MEMORANDUM

SUBJECT: Public Hearing Item No. 3 - 1498 Laurier Avenue

1498 Laurier Avenue

Enquiry Stage October 2004

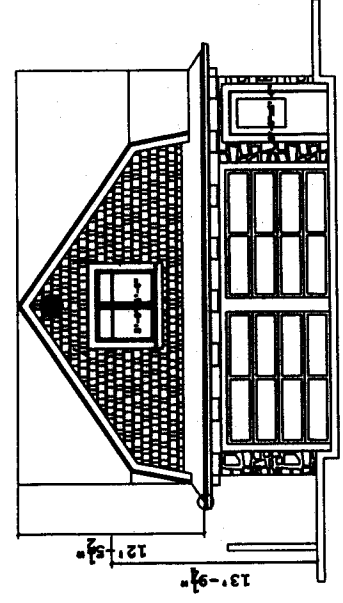
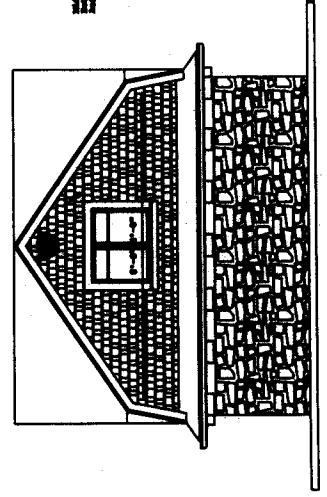
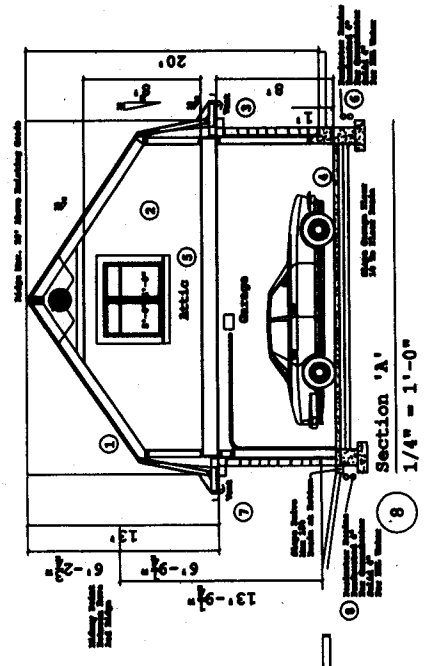
Initial Submission as Presented to First Shaughnessy Advisory Design Panel

- 1. Floor Slab Depressed 12" Below Lane
- 2. Roof Height Kept within Accessory Building Envelope

Changes following FSADP November 2004

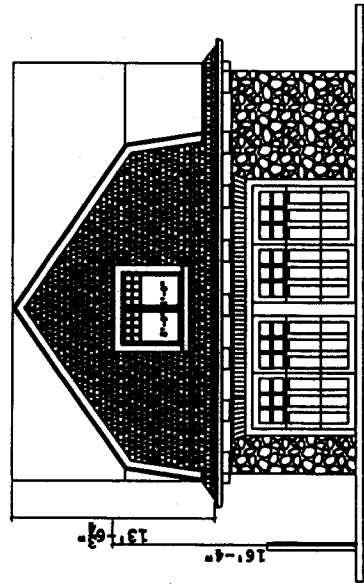
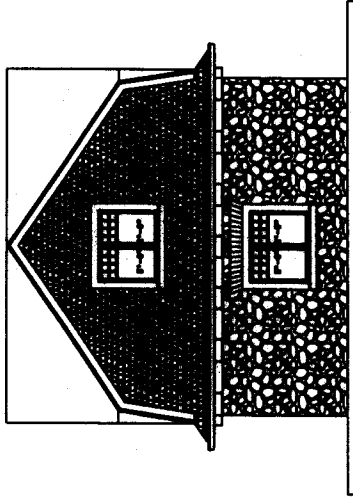
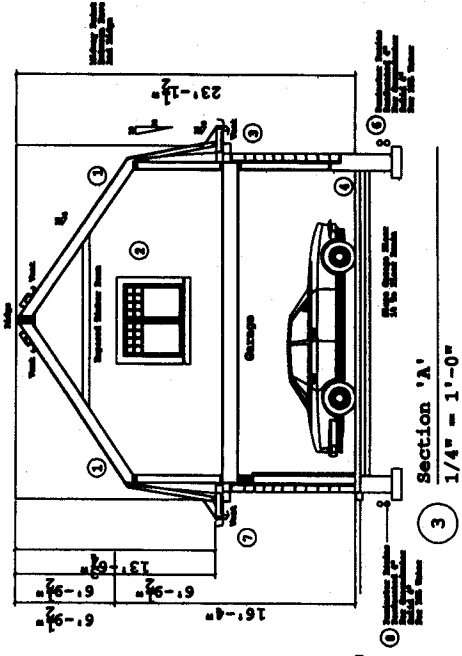
Following Recommendations Of First Shaughnessy Advisory Design Panel

1. Raise Slab Elevation to Match Lane
2. Increase height of Lower Storey to Match House Proportions

Changes to Increase Privacy

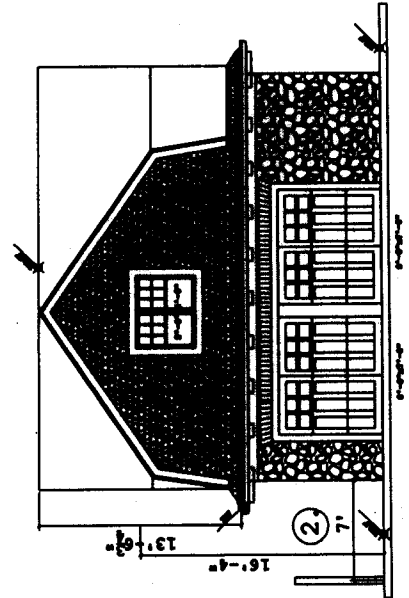
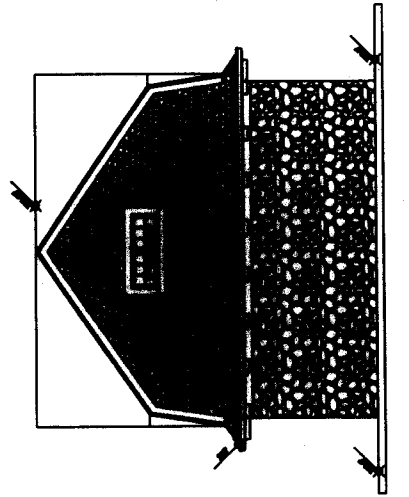
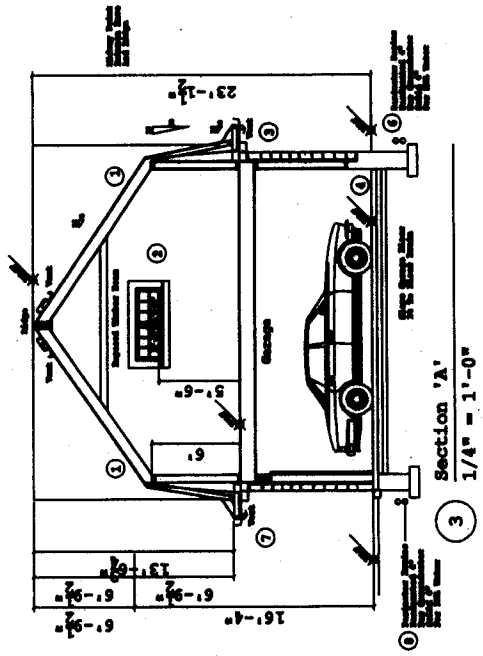
The applicant proposes to shift the location of the garage two feet to the east to compensate for the two feet in height overage, and to reduce the size and raise up the windows on the west side to prevent viewing down into the neighbour's yard. These provisions will be incorporated into the final conditions of the Development Permit.

Following Meeting with City Planners to Address Neighbour's Expressed Concerns

1. Raise Windowsill from 3' to 5'-6"
2. Increase Sideyard from 5'-0" to 7'-0"
